DEPARTMENT OF TRANSPORTATION**Federal Highway Administration****23 CFR Part 655**

National Standards for Traffic Control Devices; Revision of the Manual on Uniform Traffic Control Devices**AGENCY:** Federal Highway Administration (FHWA), DOT.**ACTION:** Notice of proposed amendments to the Manual on Uniform Traffic Control Devices (MUTCD); request for comments.

FIGURE 3A

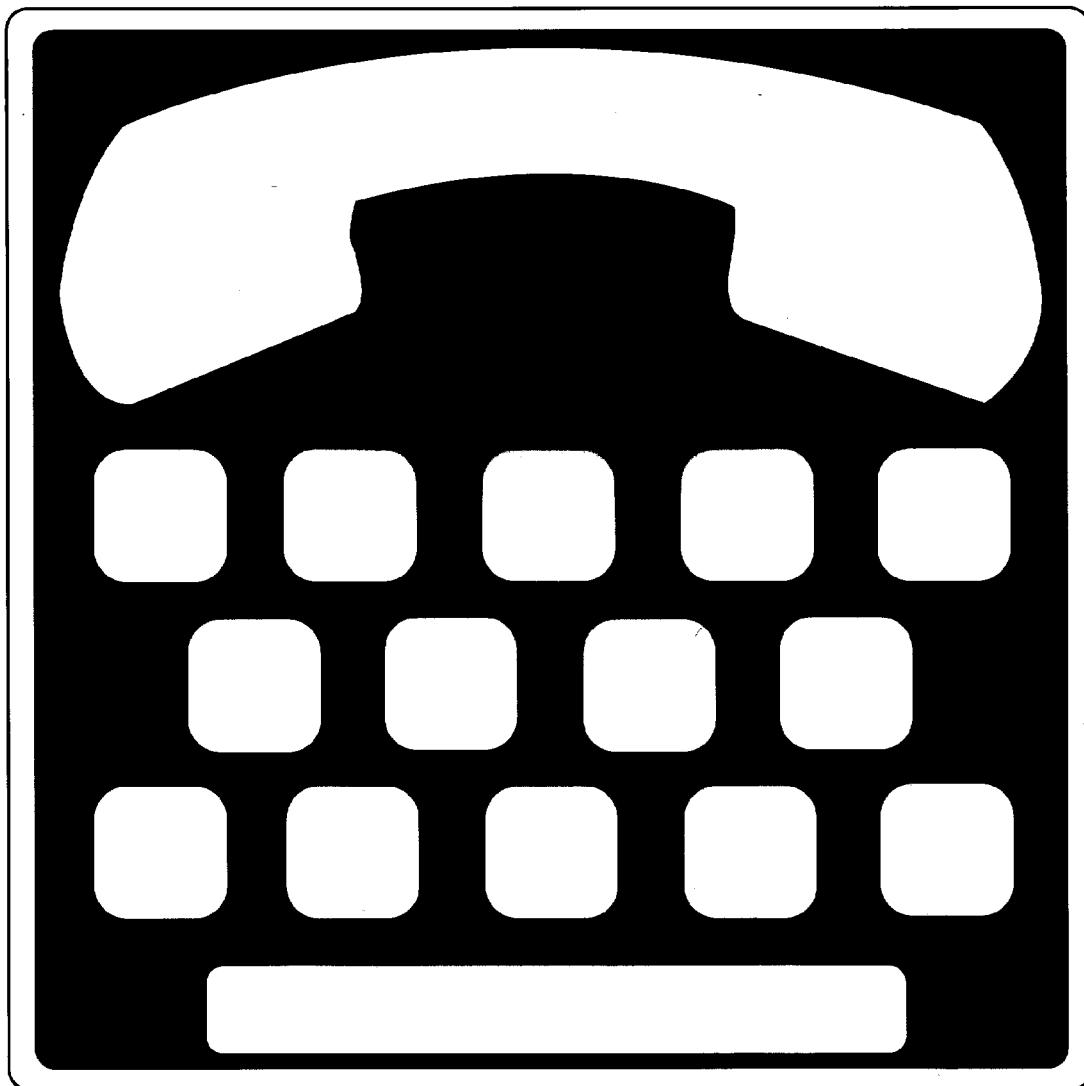
for the disabled. However, it does not contain any discussion on the design and application of the new "Van Accessible" sign. Therefore, the FHWA proposes to include the "Van Accessible" sign as a supplement to the standard R7-8 regulatory sign. When used, this word message sign should have a white background with black or green legend. Reverse background and legend colors may be used as an alternate. Where a guide sign is needed to direct motorists to special van-accessible parking facilities, the proposed "Van Accessible" sign should have a white legend on blue background with an appropriate directional arrow.

The FHWA proposes to add the design dimensions for this sign to the Standard Highway Signs Book and to add appropriate text to the MUTCD section 2B-31, "Urban Parking and Stopping Signs." The FHWA believes that this proposed amendment would impose no significant financial burden on State and local highway agencies because the "Van Accessible Sign" is intended for use only at parking locations where traffic laws and statutes apply.

The accessibility guidelines at 36 CFR part 1191 also contain construction requirements for accessible buildings or facilities. The guidelines identify facilities and elements thereof which are required to be signed as accessible. Buildings required to be accessible shall use the international symbol of accessibility as shown in figure (a) below. In addition, building requirements are also provided for signing facilities which have public text telephones and assistive listening systems. The symbol for text telephones is shown in figure (b) and the symbol for assistive listening systems is shown in figure (c).

Figure 5

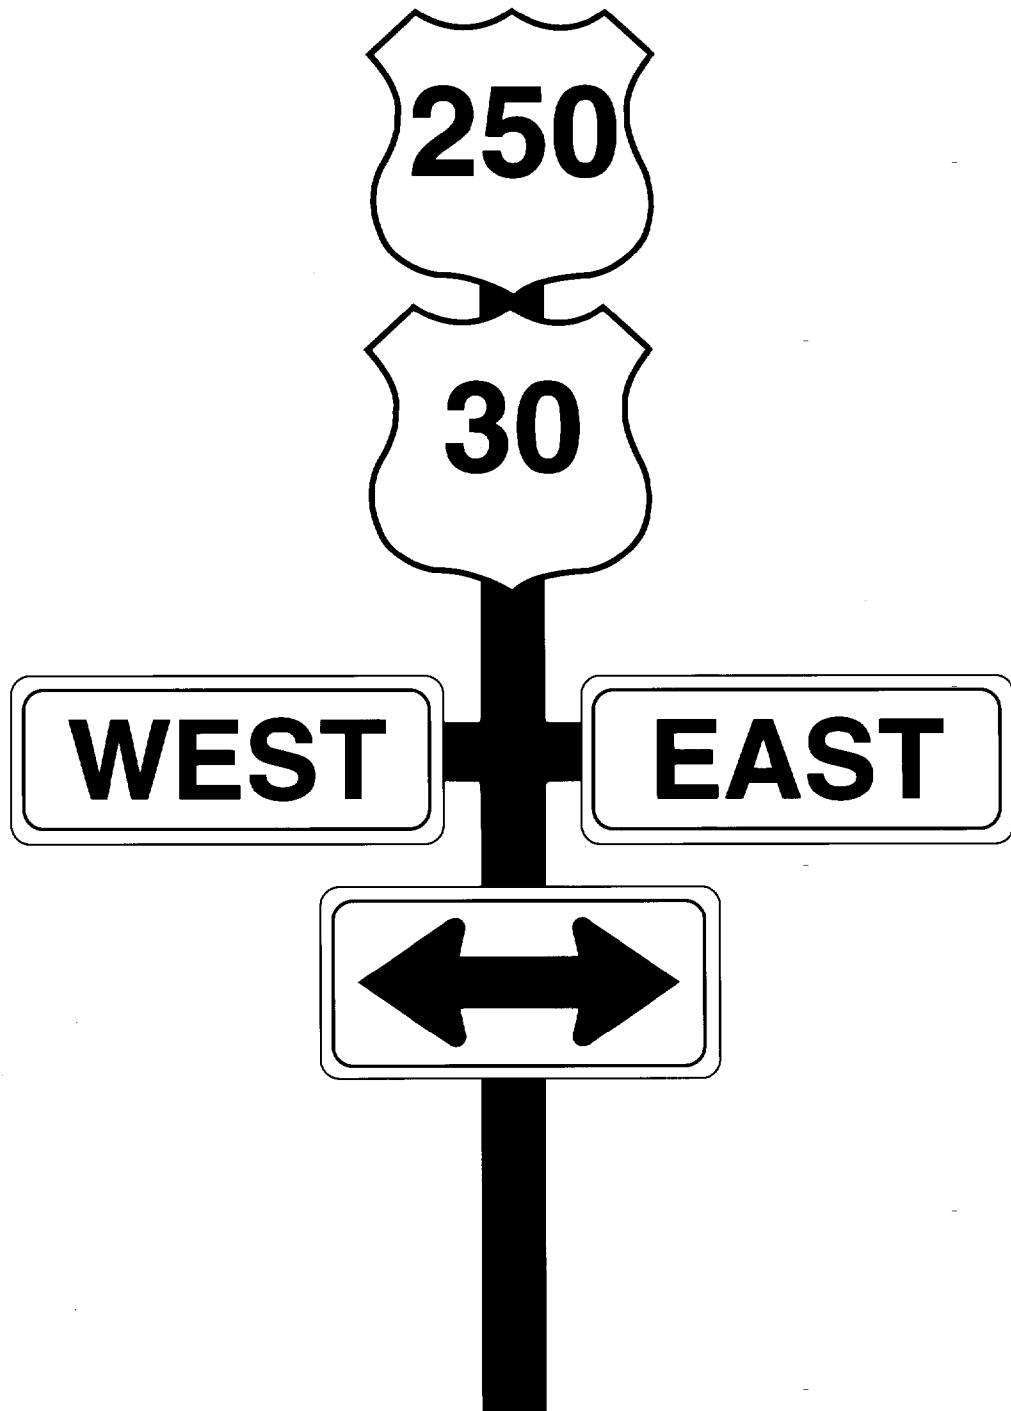
A citizen from Richmond, Virginia, has requested a change to directional assembly installations to reduce the amount of information displayed. Instead of displaying a route shield and route number for each direction of travel, the route marker assembly would display only one route shield and route number with appropriate cardinal directions and arrows.

The FHWA proposes to adopt this request for change as an optional application for use in situations where an engineering study determines that motorist confusion would not result. This proposal would impose no additional requirements or costs on highway agencies; therefore, an implementation period would not be necessary.

Figure 6

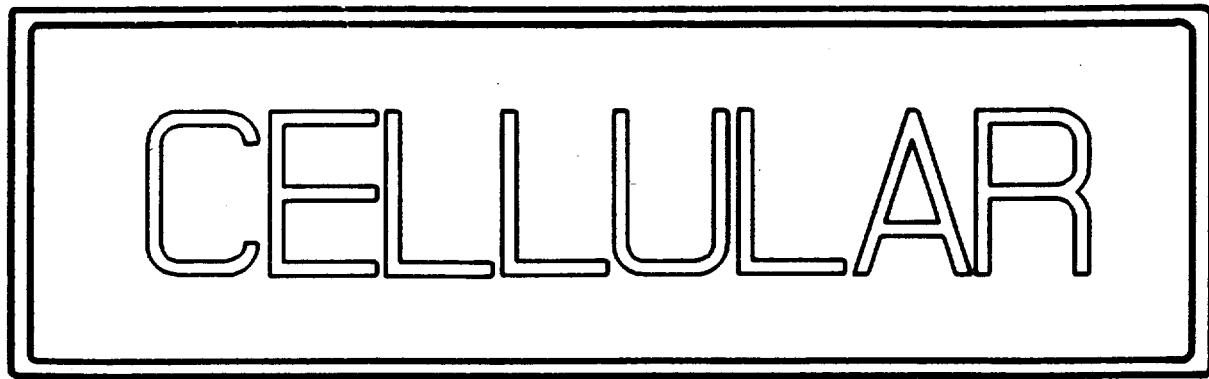
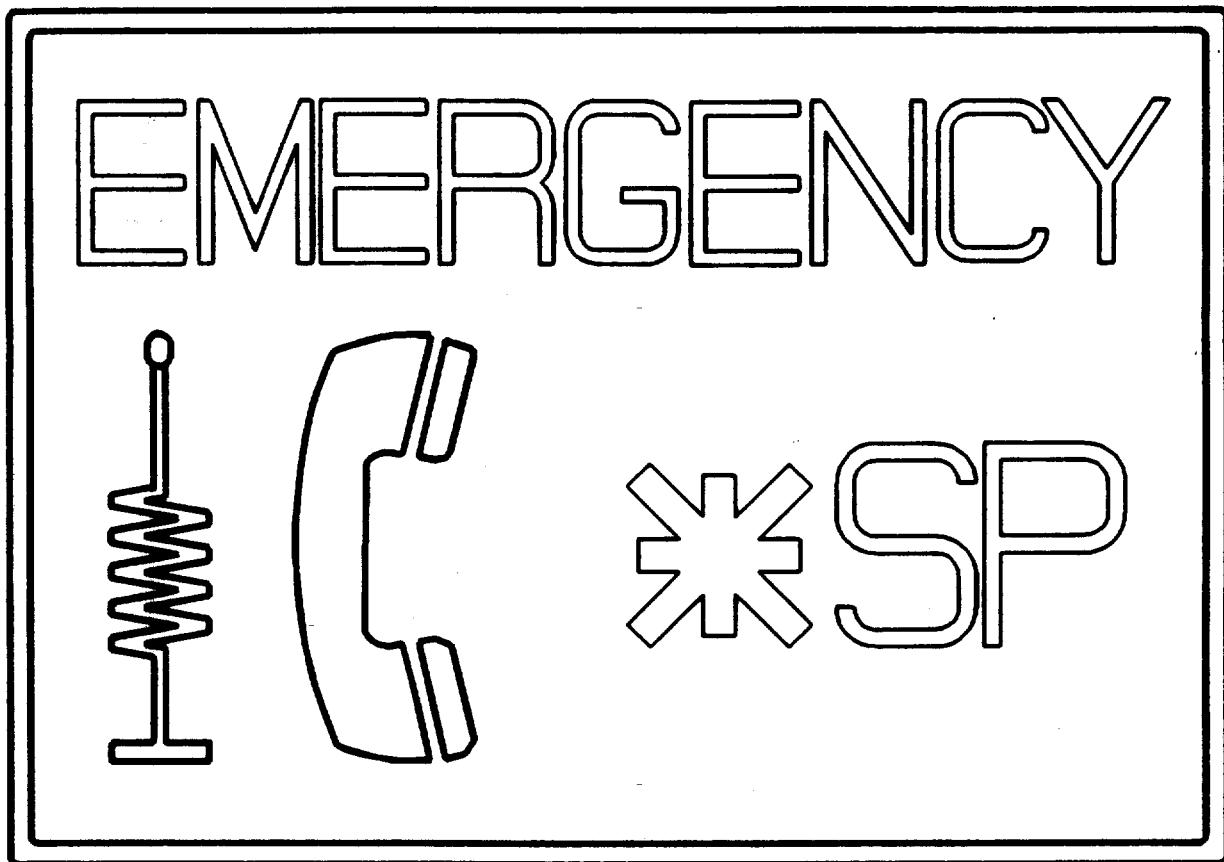
The Massachusetts Highway Department has submitted a request to include a State Police Cellular Phone Sign into the MUTCD. The proposed sign (as shown below) contains the standard telephone symbol (D9-1) and the standard police sign (D9-14). One of the prerequisites for adopting any proposed sign is that the sign message must be uniformly understood by

motorists and not create traffic safety or operational problems. Consideration is given to the sign's target value, conspicuity, and legibility. The FHWA is concerned that the antenna shown in the proposed sign drawing may not be legible to the motorist at certain distances and speeds. The FHWA is also concerned that some motorists may not comprehend the sign's intended message.

Therefore, the FHWA recommends using a word message sign similar to the standard D12-3 sign. The sign would read, "Police Monitor Cellular Phone" along with the appropriate number to dial (which may vary from region to region). This proposal would impose no requirements or additional costs on highway agencies.

Figure 7

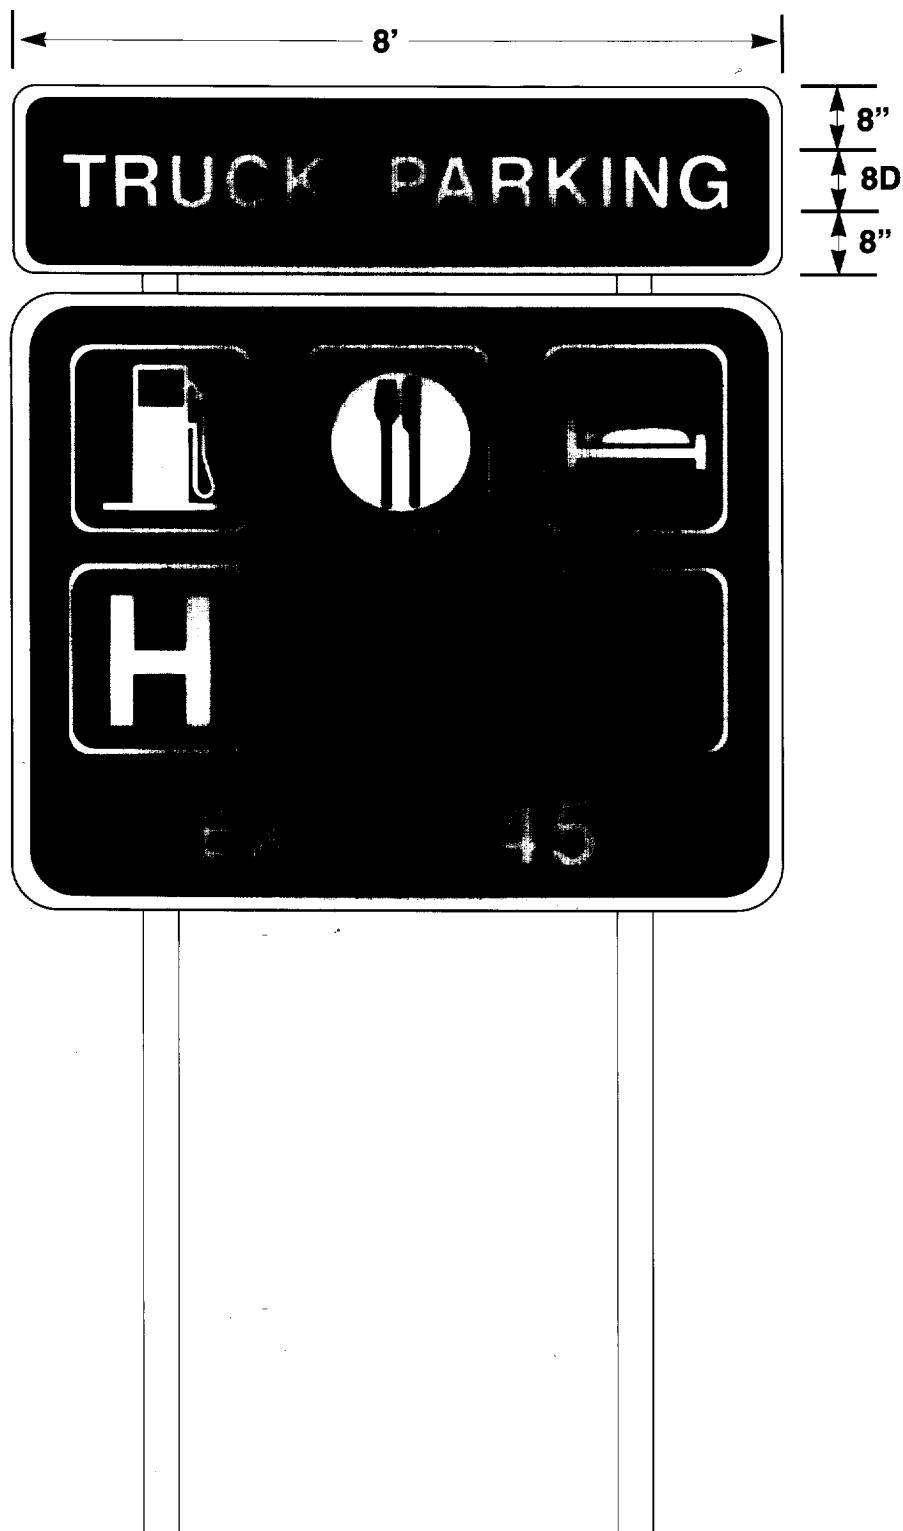
This request from the Michigan Department of Transportation (MDOT) is to include "TRUCK PARKING" as an eligible message which can be included on General Service Signs as discussed in MUTCD sections 2D-45, 2E-37, and 2F-33. This sign is only to be used where public or private parking facilities are provided near a freeway or expressway interchange.

The MDOT has experimentally used these signs since 1990 and has found the number of illegally parked trucks on shoulders and ramp acceleration/ deceleration lanes has dropped, with a substantial reduction in accidents and fatalities. In addition, truck use of rest areas has decreased while use of privately managed truck stops has increased.

While symbol signing is used for other General Service Signs, this request is to use the word message "TRUCK PARKING" above these symbols as shown in the diagram below. The FHWA supports the overall concept of this proposal and invites comments on the concept of using the word message "TRUCK PARKING" with other general service symbol signs. We also welcome suggestions for a "TRUCK PARKING" symbol.

Figure 10

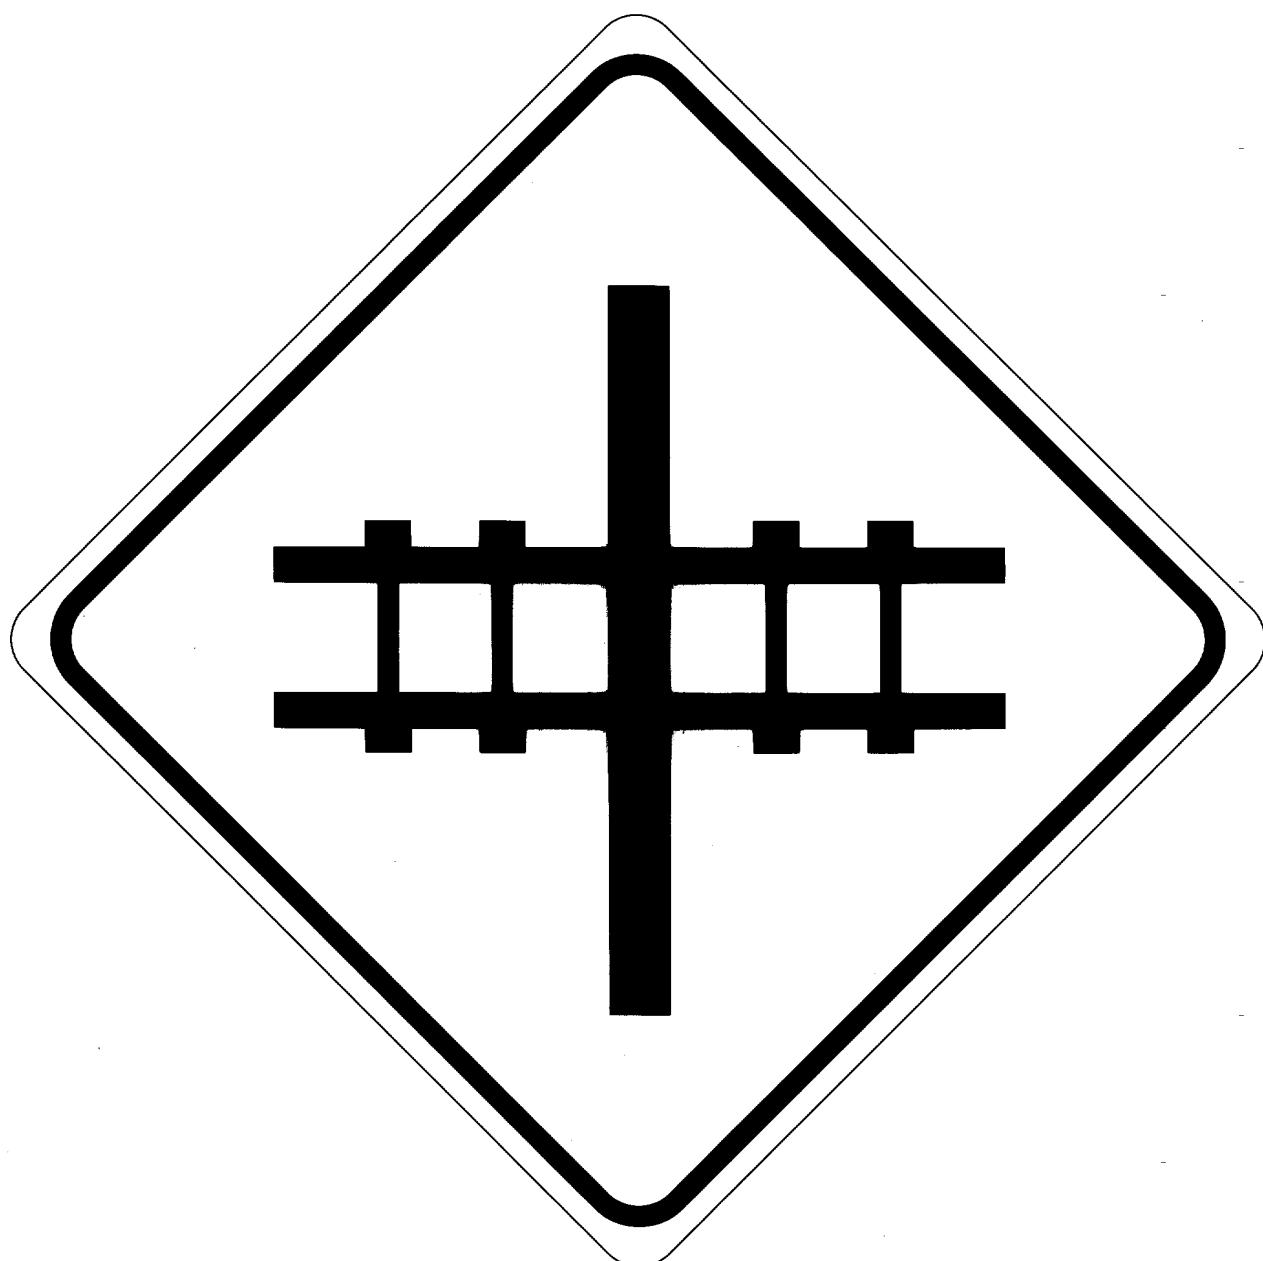
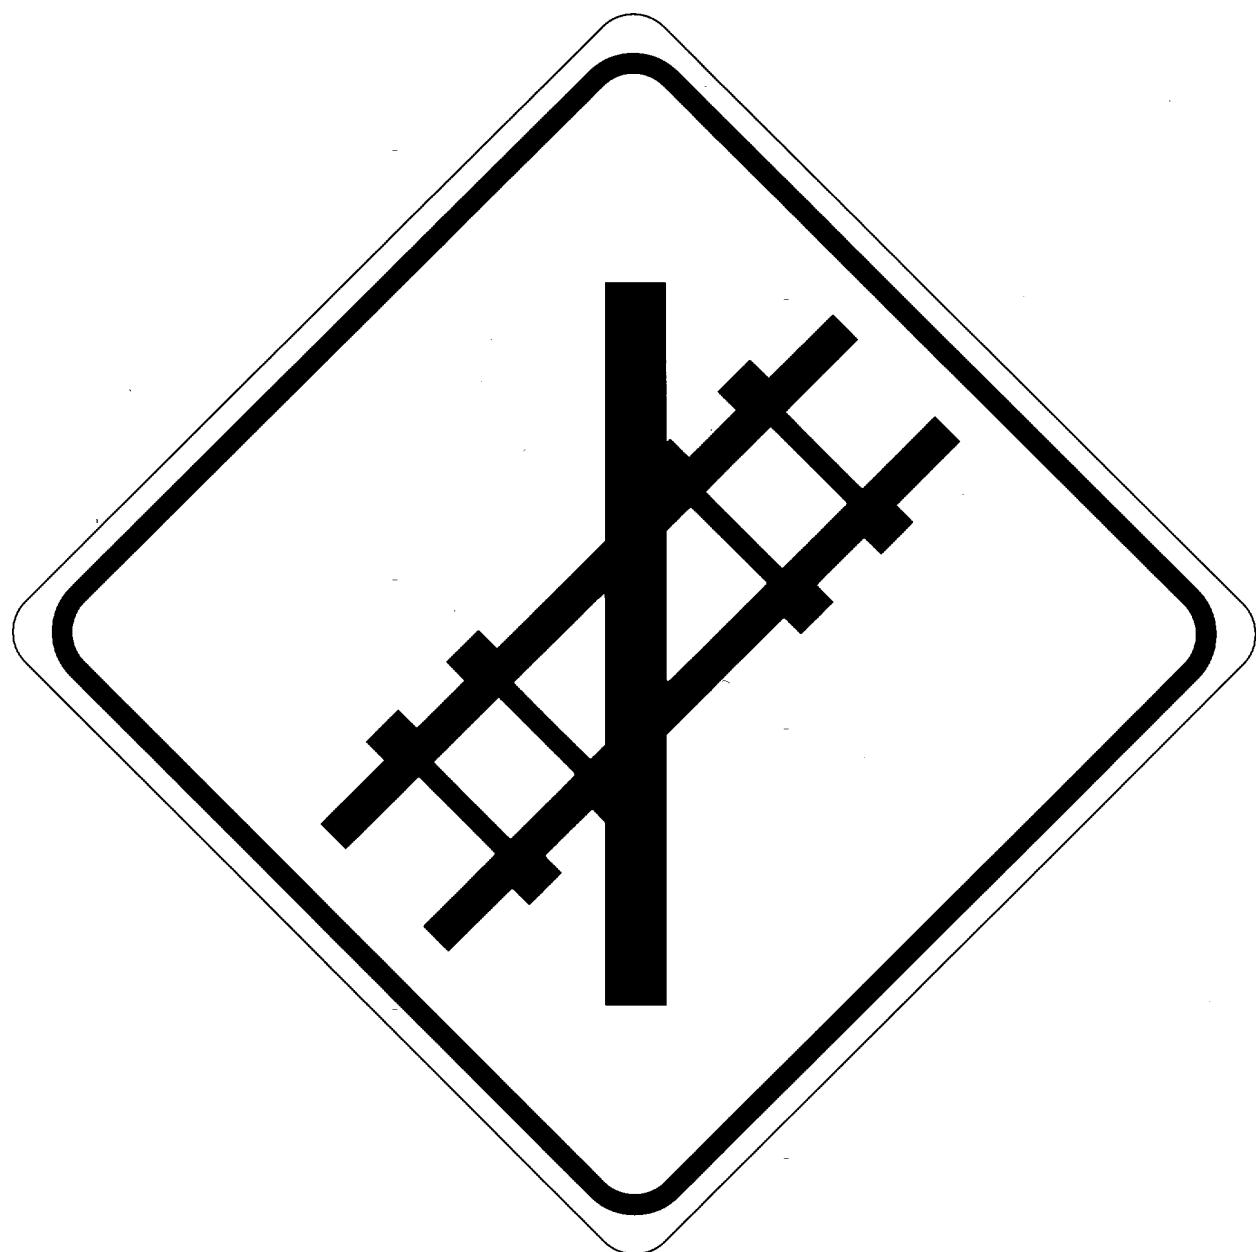
This request from a private citizen in Cheltenham, Pennsylvania, is to replace the standard round Railroad Advance Warning Sign (W10-1) with diamond shaped sign(s) as shown below. The rational for this change is that the proposed warning signs are similar to other standard warning sign "crossing" messages as contained in the MUTCD.

The FHWA is not in favor of this proposal. The round Advance Warning Sign is intentionally unique from other warning signs and is intended to convey to motorists the special attention they need to apply when approaching a railroad-highway grade crossing.
